HIGHLAND COUNCIL

Report Title: 21/02982/FUL: Mrs Bernadette Church

Land 60M NW Of Foresters Cottage, Newtonhill, Lentran, Inverness

Description: Erection of hut

REF 21/02982/FUL ERECTION OF HUT ON LAND 60M NW OF FORESTERS COTTAGE NEWTONHILL, LENTRAN, INVERNESS, IV3 BRN BERNADETTE + GERARD CHURCH AMENDED SITE PLAN FOR PARKING + ACCESS AT PROPOSED HUT 9TH MAY 2022

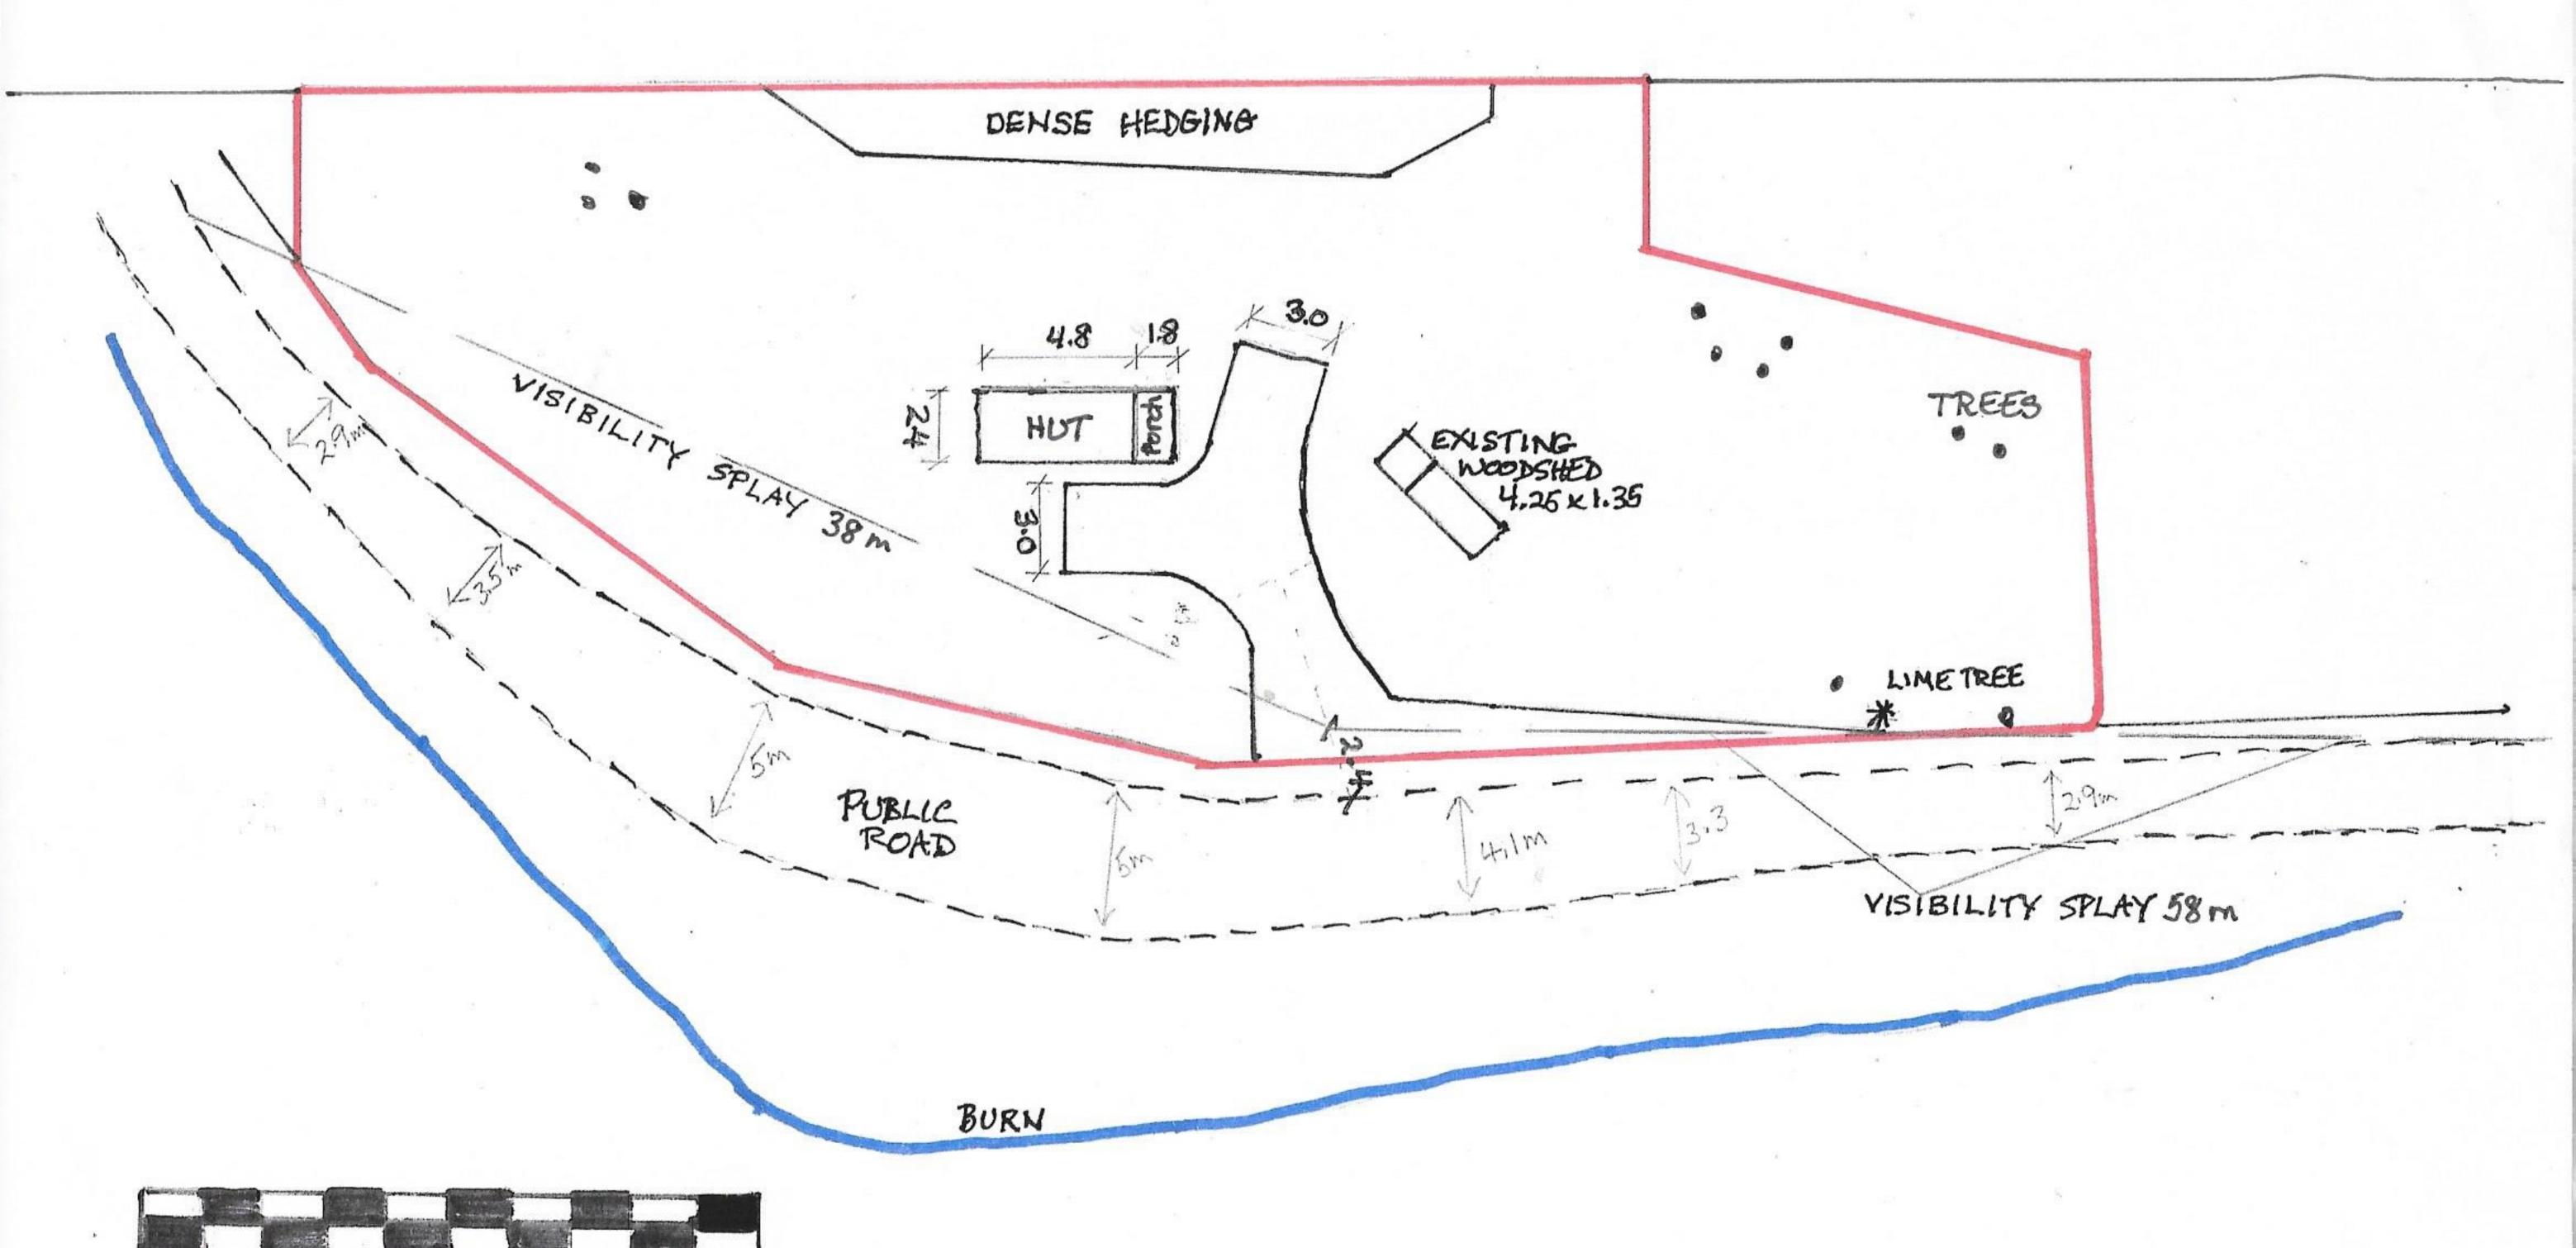
- 5.5 **Transport Planning Team** Originally objected due to lack of roads information including no Private Access Checklist or visibility splay drawing. On receiving the additional information required, the objection has been maintained. The site entrance is non-compliant, there is a significant shortfall in visibility splay provision, and the proposed site entrance is located at an inappropriate location relative to the public road.

- 8.13 A technical site inspection was undertaken by both the Transport Planning and Planning Officers to assess the access. Although vehicle speeds are relatively low on this section of the road due to the gradient and the bends both to the south (uphill) and north (downhill), the Transport Planning Team's formal assessment is that the proposed access does not meet the minimum required technical standards, particularly with regards to forward visibility. It also noted that there is no space within the site for a vehicle to turn which would result in vehicles potentially reversing from/into the public road from the site. It must be recognised that the very essence of a hut is to be low impact where minimal hard surfacing should be required. However, this should not be to the detriment of road safety, either for the occupant or other road users.

- 9.5 However, the proposed access arrangements to the site are not considered to meet the minimum technical standards, with the access being placed on the inside of a bend on a single-track road, with the visibility splays both up and downhill being below the required standard. Accordingly, it is not considered that the proposal is acceptable with regards to the road safety and road servicing requirements of the Highland wide Local Development Plan policy 28 Sustainable Design.

1. The proposed access arrangements to the site are not considered to meet the minimum technical standards, with the access being placed on the inside of a bend on a single-track road, with the visibility splays both up and downhill being below the required standard. In addition, the proposal has not demonstrated that there is appropriate in-curtilage parking and turning space to prevent vehicles reversing from/into the public road from the site. Accordingly, it is not considered that the proposal is acceptable with regards to the road safety and road servicing requirements of the Highland wide Local Development Plan policy 28 Sustainable Design.
